**CHARTER TOWNSHIP OF VAN BUREN
PLANNING COMMISSION
May 24, 2023
MINUTES**

ITEM #1: CASE 22-052 – ASHLEY CROSSROADS NORTH SITE PLAN AMENDMENT / OUR NEXT ENERGY (ONE) PRELIMINARY AND FINAL SITE PLAN.

Subject: VBT-22-052 – ONE (Our Next Energy) CRN – Building 6/42060 Ecorse Road; Prototype PHASE 1/Site Plan Review #3; Revised Plans Dated May 9, 2023.

**Our Next Energy – Ashley Crossroads North
Phase 1 Preliminary/Final Site Plan Review**

Sheet CS1-SPA-PH1

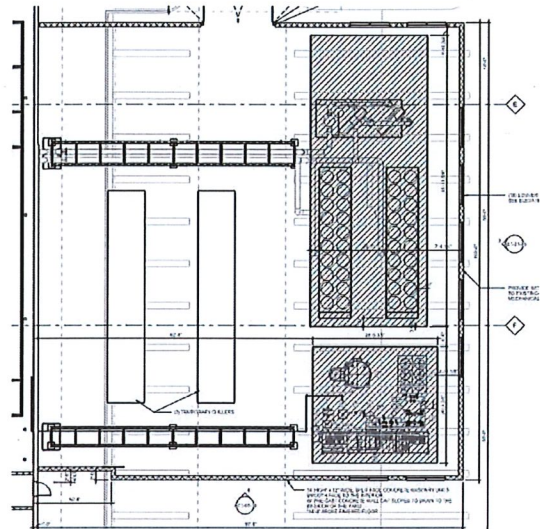
4. There are different plan views in the submitted plan set of the mechanical yard being added to the east side of the building and they do not all match each other. For example, the mechanical yard on sheet CS1-SPA-PH1 shows permanent chillers, and SRS system, two temporary chillers in the northwest corner of the yard and a single permanent chiller trestle going from the building to the permanent chillers. The mechanical yard

plan on sheet AE1-01-19 shows two trestles and the temporary chillers in the south. Plans must match and show the actual equipment and layout being proposed.

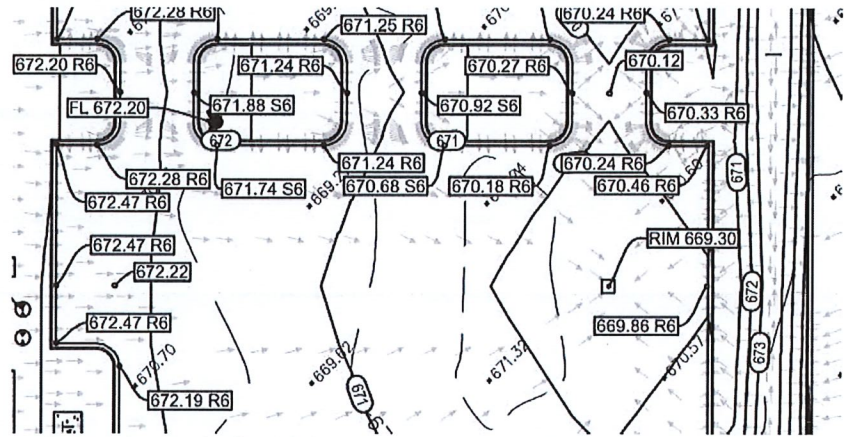
- An existing sanitary manhole is indicated to be located within the temporary/permanent chiller enclosure. An access detail is shown on the plans however, additional details will need to be provided including accessibility for Township maintenance staff. Will the access gate be locked? Will the Township be able to unlock the gate if necessary?
- As stated previously, the layout of the mechanical yard on sheet AE1-01-19 does not match the layout of the mechanical yard on the site plan which shows the access to the existing sanitary manhole. On sheet AE1-01-19, the temporary chillers are in the southwest corner of the yard and potentially on top, or directly adjacent to the sanitary manhole, which is not what is depicted in the sanitary access detail. There also appears to be

two trestles shown between the building and the permanent chillers and SRS system instead of one. The sanitary access detail should be revised to match the actual mechanical yard layout and show vertical and horizontal clearances around the manhole. The plans should also indicate the accessibility/turning movements for the largest Van Buren maintenance vehicle (vacator truck).
